**Proposed Highway Works
Associated with Dewsbury
Riverside Development**

Stage I Road Safety Audit

November 2022

2.1 Problem

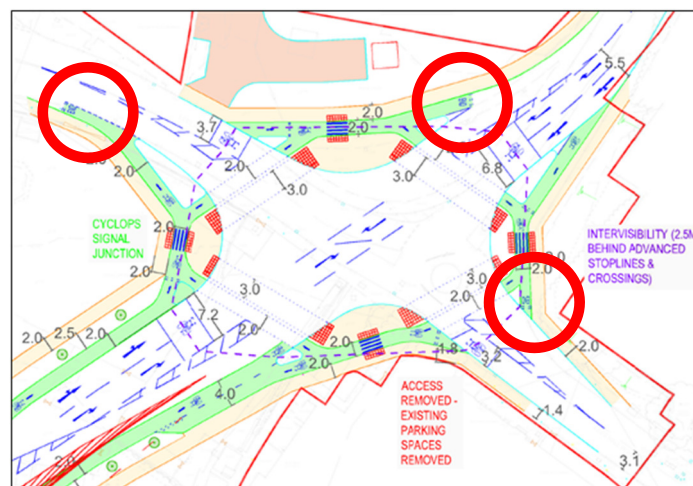
Location: Ravensthorpe Road / Forge Lane / Lees Hall Road / Link Road traffic signal junction

Summary: Risk of late braking/rear end shunt collisions and collisions with pedestrian crossing users due to positioning of traffic signal heads

The supplied drawing does not indicate where the traffic signal heads are to be positioned. Although traffic islands are provided on three arms of the junction (within which it may be possible to provide primary traffic signal heads), it is not clear where the primary traffic signal heads on Lees Hall Road would be positioned. In addition, the lack of physical central islands means that any duplicate primary signal heads will need to be provided on the offside of the approaches. Visibility of these signal heads is likely to be particularly important in situations when high-sided vehicles mask the primary signal heads. If suitable visibility of the traffic signals is not provided, an increased risk of late braking and rear end shunt collisions, as well as possible collisions with pedestrian crossing users could be expected.

- 1) It is recommended that the positioning of the traffic signal heads is suitably established; and
- 2) It is recommended that an appropriate forward visibility envelope is provided at all traffic signal head locations and that the visibility distance is commensurate with expected vehicle approach speeds.

2.2 Problem

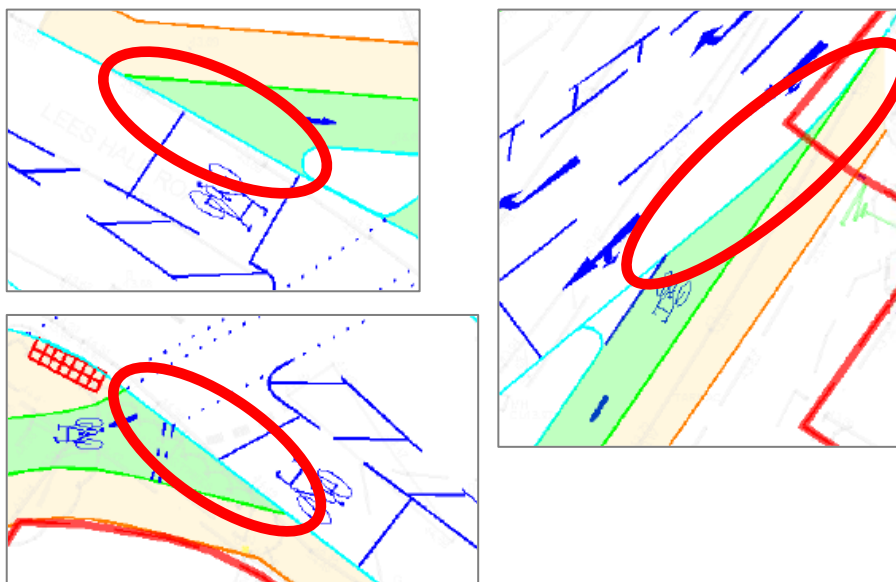
Location: Ravensthorpe Road / Forge Lane / Lees Hall Road / Link Road traffic signal junction

Summary: Risk of vehicle/cyclist collisions due to discontinuation of cycle facilities at the junction exits

Although the traffic signal junction provides dedicated facilities for cyclists around the junction, on three of the four exit arms (northern, eastern and western) cyclists are required to exit the junction directly onto the carriageway and share road space with motorised users. It is acknowledged that constraints on existing roads are likely to limit the ability to continue with protected cycle facilities, but in attempting to re-join the carriageway, cyclists are likely to be vulnerable to side-swipe collisions from vehicles travelling through the junction. The northern and eastern cycle slips bring cyclists onto the carriageway very close to the controlled area of the junction. The western cycle slip would bring cyclists onto carriageway close to a location where on-street car parking takes place and is likely to require cyclists to make sharp movements to avoid the parked vehicles, which may bring them into conflict with other road users.

It is recommended that the arrangements which require cyclists to re-join the carriageway upon exiting the junction are reviewed, with suitable design enhancements made which offer improved safety benefits for cyclists.

2.4 Problem

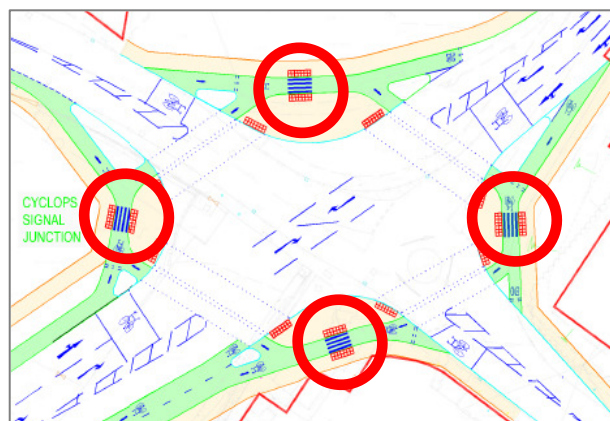
Location: Lees Hall Road approach to the Ravensthorpe Road / Forge Lane / Lees Hall Road / Link Road traffic signal junction

Summary: Increased general collision risk due to alignment of the traffic signal stop line

The stop line on the Lees Hall Road approach to the Ravensthorpe Road / Forge Lane / Lees Hall Road junction is shown as not being perpendicular to the kerb. This could be confusing for road users and increase general collision risk.

It is recommended the design is amended to show the stop line as being perpendicular to the kerb.

2.6 Problem

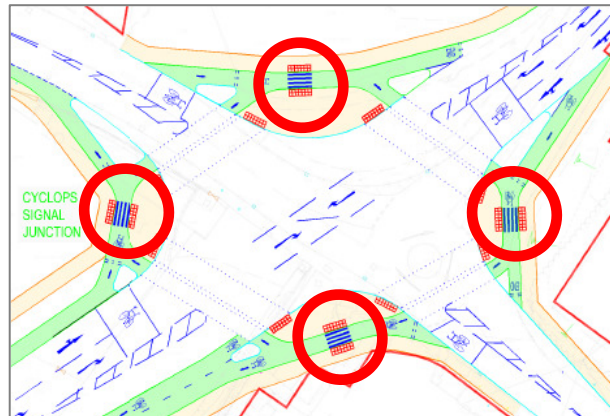
Location: Ravensthorpe Road / Forge Lane / Lees Hall Road / Link Road traffic signal Junction

Summary: Risk of pedestrian/cyclist collisions due to tactile paving arrangements at the crossing facilities

'Cyclops' junctions are relatively new junction designs and tactile paving layouts at these junctions are generally not well defined. Tactile paving crossing points are provided across the cycle facilities at the junction. However, on the outer tactile paving, no stem is provided to guide blind/visually impaired pedestrians to the crossing. This may mean that blind/visually impaired pedestrians are unable to locate the crossing effectively, therefore increasing their risk of unintentionally walking out into the cycle facility where they would be at increased risk of collision with approaching cyclists. Generally, at 'Cyclops' junctions, the use of 'L' shaped tactile paving (i.e.; tactile paving with a stem) shows the start and end points of a complete crossing of the junction, with the remaining tactile points being 'uncontrolled'.

It is recommended that the design is suitably amended to include stems on the outer most tactile paving at the cycle facility crossings.

2.7 Problem

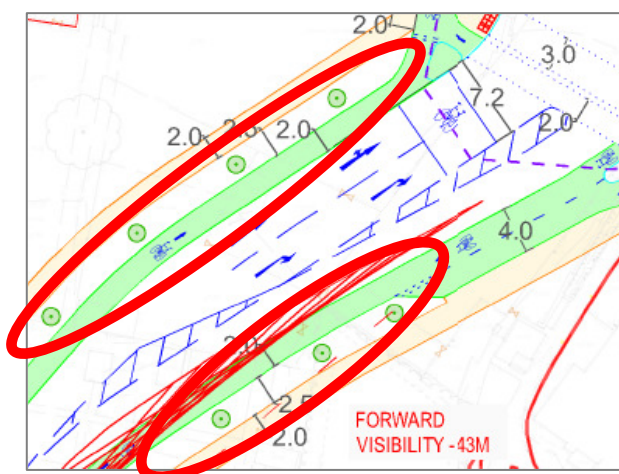
Location: Ravensthorpe Road / Forge Lane / Lees Hall Road / Link Road traffic signal Junction

Summary: Risk of pedestrian trip/fall injuries when crossing the cycle facility

A half height kerb is shown at the pedestrian crossing points and is likely to represent a trip/fall hazard for pedestrians attempting to cross the cycle facility.

It is recommended that flush kerbs are provided at all pedestrian crossing points.

2.9 Problem

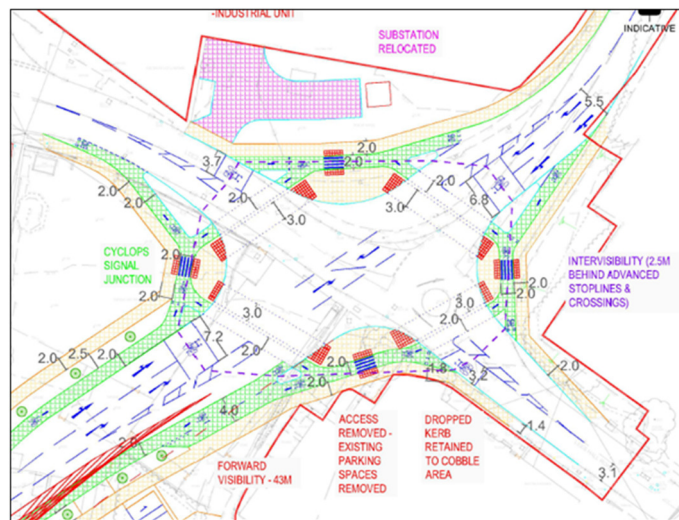
Location: Ravensthorpe Road / Forge Lane / Lees Hall Road / Link Road traffic signal Junction

Summary: Risk of collisions between HGVs and other road users due to turning requirements at the junction

Vehicle swept path information has been supplied for the junction and demonstrates that, although there is very little margin for error, a large articulated vehicle is expected to be able to manoeuvre through the junction. There are some movements (such as the south to west articulated vehicle movement shown below) where the vehicle body of the turning articulated vehicle is very close to an opposing traffic lane/ASL. The simulated speed of the vehicle tracking has not been provided. If a particularly low simulated speed has been used (e.g.; less than 5mph) this produces a tighter tracking profile. A vehicle turning in excess of this speed (which is likely) would have a slightly wider tracking profile and may be encroach into the into opposing lane/ASL, increasing the risk of collisions with road users using these spaces.

It is also noted that as a number of large vehicle turning movements at the junction overrun central hatched areas, it is unlikely to be possible to provide physical islands in these locations to install any duplicate primary traffic signal heads.

It is recommended that the simulation speeds of the HGV swept paths are checked at the junction to ensure that the required large vehicle turning movements can be appropriately accommodated. If the swept paths cannot be suitably accommodated, then the junction design should be modified accordingly.

2.12 Problem

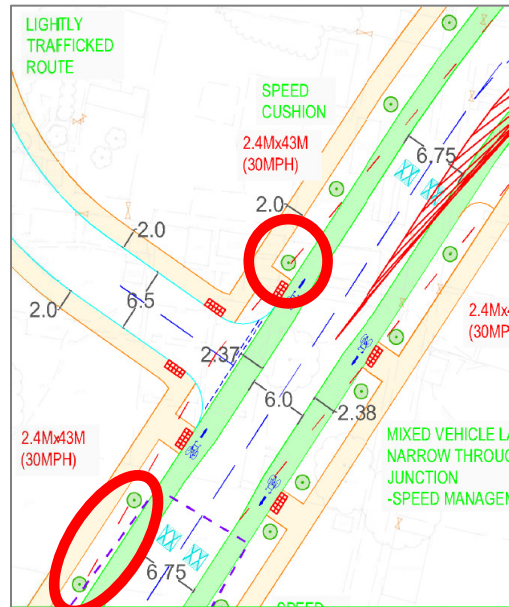
Location: Junction on link road

Summary: Risk of cyclists/pedestrian collisions and pedestrian trip/fall injuries due to proposed pedestrian crossing arrangements.

Two uncontrolled pedestrian crossings are proposed across the link road within the vicinity of the side road junction. Pedestrians are required to cross two cycle lanes and a two-lane carriageway. It is likely that whilst waiting/looking for a crossing gap, some pedestrians would wait within the extents of the cycle facility. In doing so, they would be at an increased risk of collision with approaching cyclists.

In addition, half height kerbs are shown at the pedestrian crossing points and are likely to represent a trip/fall hazard for pedestrians attempting to cross the cycle facility. As a general note, it is difficult to determine from the scheme drawings the extent of any level difference between the cycle facility and the adjacent footway/carriageway areas (i.e.; is the cycle facility at carriageway level, footway level or an intermediate level).

It is recommended that the design of the crossing points is modified so that pedestrians can cross the cycle facility and carriageway in separate stages and that flush kerbs are provided at all pedestrian crossing points.

2.14 Problem

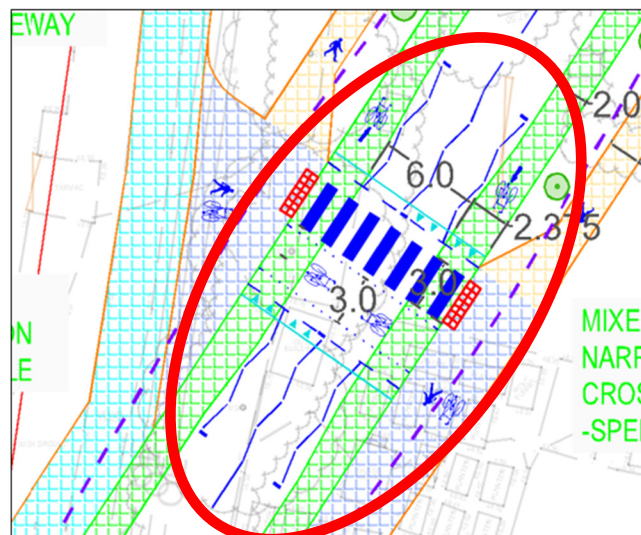
Location: Northern parallel crossing on link road

Summary: Risk of various collision types due to the design of the crossing facility

A raised parallel crossing is proposed approximately mid-way along the link road. As it is a controlled crossing, a tactile paving stem on the pedestrian section of the crossing should extend to the back of the footway so as to guide blind/visually impaired pedestrians to the crossing. A stem has not been provided and may mean that blind/visually impaired pedestrians are unable to locate the crossing effectively, therefore increasing their risk of unintentionally walking out into the carriageway where they would be at increased risk of collisions with approaching vehicles/cyclists.

The carriageway ramps either side of the raised crossing appear to be the same length as those on the cycle track. This suggests that an excessively steep ramp could be provided for vehicles, increasing the risk of loss of control collisions.

The link road cycle facilities also run straight through the parallel crossing facility, with no requirement for cyclists to give way to waiting pedestrians/cyclists. As such, it is likely that some pedestrians/cyclists waiting to cross the link road would wait within the extents of the link road cycle facility. In doing so, they would be at an increased risk of collision with approaching cyclists.

The kerbing arrangement at the crossing facility is also unclear. The crossing appears to be flush (as is on a raised facility) but a half height kerb is shown on the cycle facility and is likely to represent a trip/fall hazard for pedestrians attempting to cross the cycle facility.

The crossing proposals also only show four zig zag markings instead of the standard eight marks.

It is recommended that the design of the crossing is suitably amended taking into account the identified points.

2.15 Problem

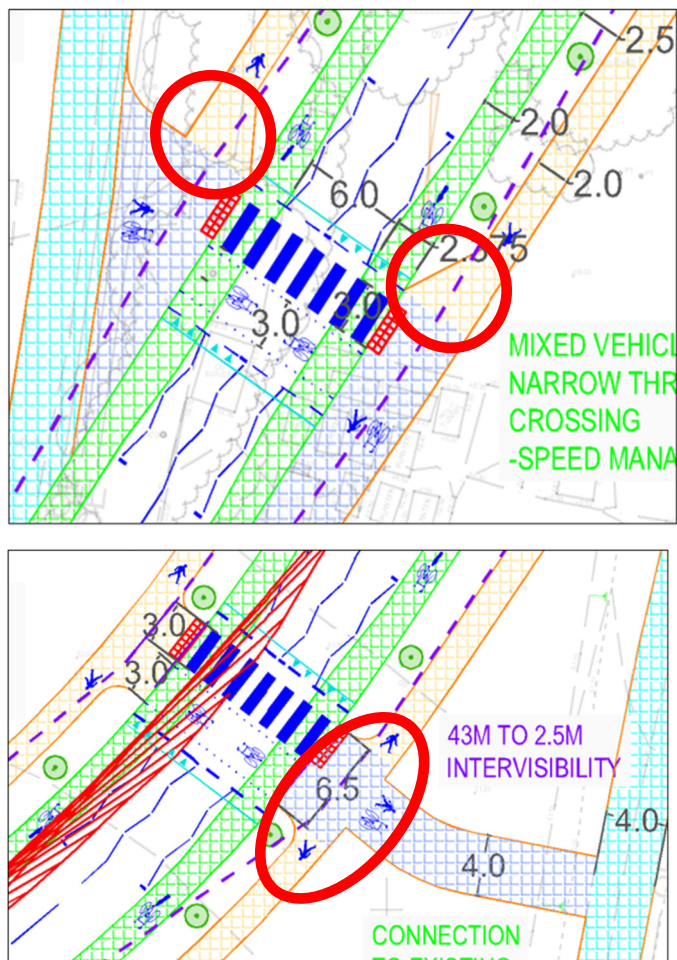
Location: Southern parallel crossing on link road

Summary: Risk of various collision types due to the design of the crossing facility

The problems identified above at the northern parallel crossing, also apply at the southern zebra crossing:

- Incorrect tactile paving at the crossing point;
- Excessively steep ramps for vehicles at the crossing;
- Link road cycle facilities continuing through the crossing facility;
- Unclear kerbing arrangement at the crossing facility; and
- Reduced number of zig zag road markings.

It is recommended that the design of the crossing is suitably amended taking into account the identified points.

2.19 Problem

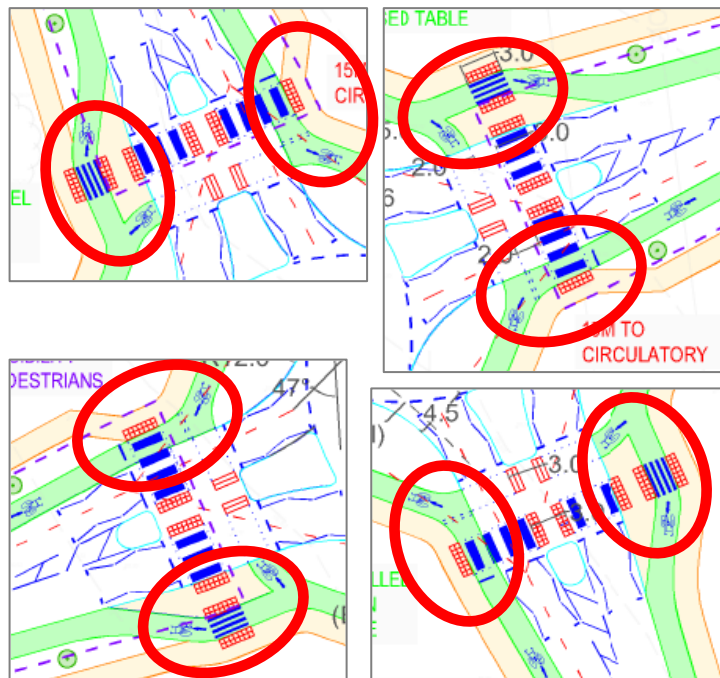
Location: Parallel crossings on approaches to the link road roundabout

Summary: Risk of collisions involving pedestrians as a result of the proposed crossing arrangements

The proposals show pedestrians crossing the cycle track and approach traffic lane in one movement on all four approaches to the roundabout. It is likely that whilst waiting/looking for a crossing gap, some pedestrians would wait within the extents of the cycle facility. In doing so, they would be at an increased risk of collision with approaching cyclists. It is unclear why on the exit arms, a different method of crossing which includes separate crossings of the cycle facility and traffic lane is provided. Whilst this method is considered preferable to the crossing method on the approach arms, the differences in provision are likely to confuse users as it would be reasonable to expect the same crossing method on both sides of the road.

As previously outlined, the half-height kerbs where pedestrians cross the cycle track would form a trip/fall hazard.

It is also noted that the offset distance between the pedestrian and cyclist parts of the parallel crossing appears excessive. This may lead to motorists considering the second half of the crossing as a separate facility or not to see it. TSRGD shows the layout of a parallel crossing (Schedule 11, Part 2 Item 53) with 0.4m offset between the two crossings.

It is recommended that the design of the proposed crossings are suitably amended taking into account the points identified above.

2.22 Problem

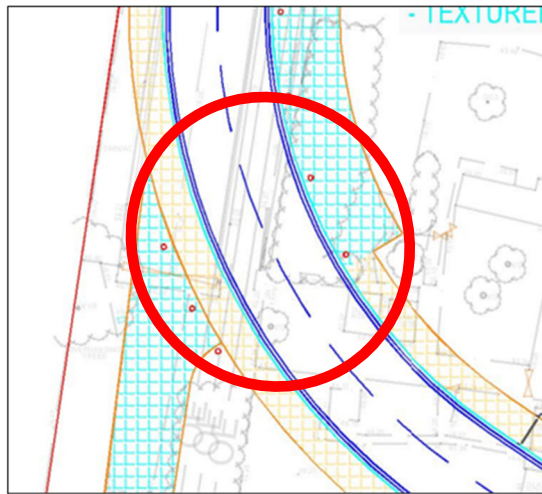
Location: Ravensthorpe Road / Link Road connection

Summary: Risk of loss of control collisions, particularly for two-wheelers due to traffic calming arrangements

It is not possible to scale from the drawings provided, but the gaps between the speed cushions and the kerb may be insufficient to allow a two-wheeler to safely navigate between the two, without losing control and potentially falling from their motorcycle/cycle. 'LTN 1/07' suggests that "the gap between the lower edge of a cushion and the nearside kerb should be no less than 750 mm (1000 mm preferred)" (DfT, 2007).

Linked to the above, the southern set of speed cushions appear to be parallel to the northern set rather than being parallel to the adjacent kerb.

It is recommended that the speed cushions are positioned with gaps that are in line with the requirements of 'LTN 1/07' (DfT, 2007) and that they are positioned parallel to the adjacent kerbs.

2.23 Problem

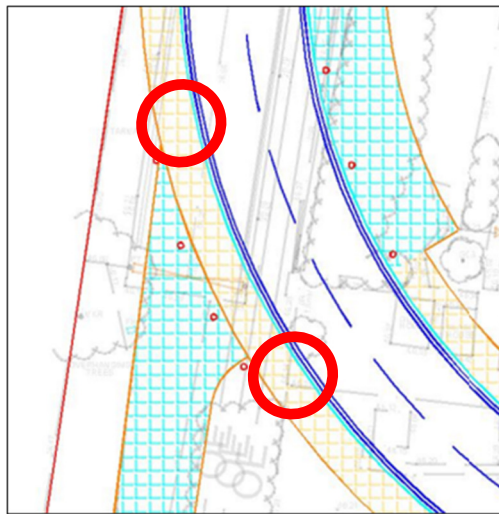
Location: Bridleway connection to Ravensthorpe Road / Link Road connection

Summary: Risk of cyclist loss of control collisions and pedestrian trip/fall injuries

The scheme proposals show the Bridleway joining the Ravensthorpe Road / Link Road connection at an acute angle. At the transition point between carriageway/Bridleway, a generally acute angle of approach is provided and if even a minimal kerb upstand is provided, it is likely to form a loss of control hazard for cyclists (particularly those on narrow wheeled bicycles). It is noted that kerb check at the transition is referenced as being full height kerbs. There is also no crossing point between the two sides of the Bridleway. This is likely to result in an increased risk of pedestrian trip/fall injuries and cyclists losing control as they have to 'bump' up and down kerbs.

- 1) It is recommended that a flush kerb arrangement is provided at all locations where cyclists transition from on-road to off-road areas; and
- 2) It is recommended that a suitable crossing facility is provided to connect both sides of the Bridleway.

2.25 **Problem**

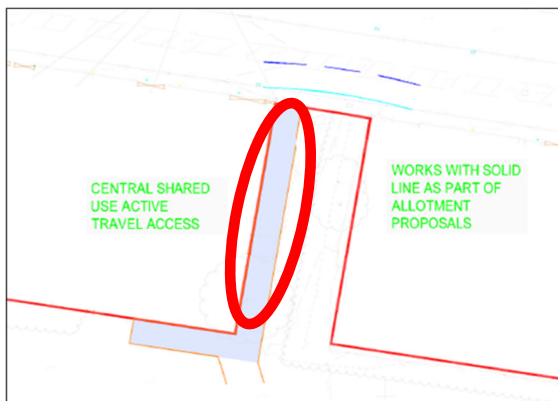
Location: Eastern access link from Ravensthorpe Road

Summary: Risk of vehicle side-swipe collisions due to limited carriageway width

The eastern access link from Ravensthorpe Road has been provided on site. It is assumed that the carriageway is to be used on a two-way basis, but it measures only 4.0m in width and is without radii at its junction with Ravensthorpe Road. This is not considered a sufficient width to comfortably cater for two-way vehicle flows and, as such, an increased risk of vehicle side-swipe collisions is expected. Although an area which could be used as a passing place has been provided at the southern end of the link, it is some distance from Ravensthorpe Road and is likely to be of limited use due to limited visibility of vehicles turning in from Ravensthorpe Road.

It is recommended that, if the access road is intended to be used on a two-way basis, it is suitably increased in width to accommodate such use.

2.26 Problem

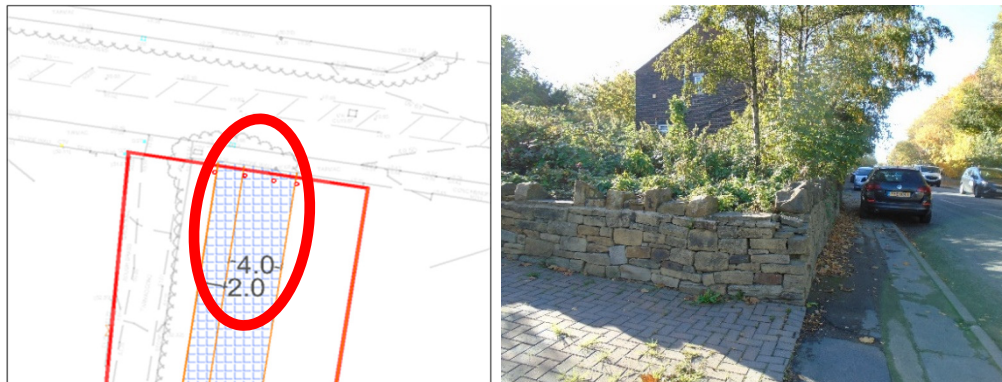
Location: Eastern access link from Ravensthorpe Road

Summary: Risk of cyclists losing control and pedestrians slipping/falling due to surface conditions

The surface that has been provided for active travel users (the area closest to the wall/fence) consists of loose stone and is considered to form a potential loss of control risk for cyclists and a slip risk for pedestrians. The risk is greatest in the south-to-north direction given the downhill gradient. The surface is also likely to deteriorate over time and form a greater road safety risk in wet conditions.

It is recommended the loose stone surface for pedestrians/cyclists is replaced with a bound surface.
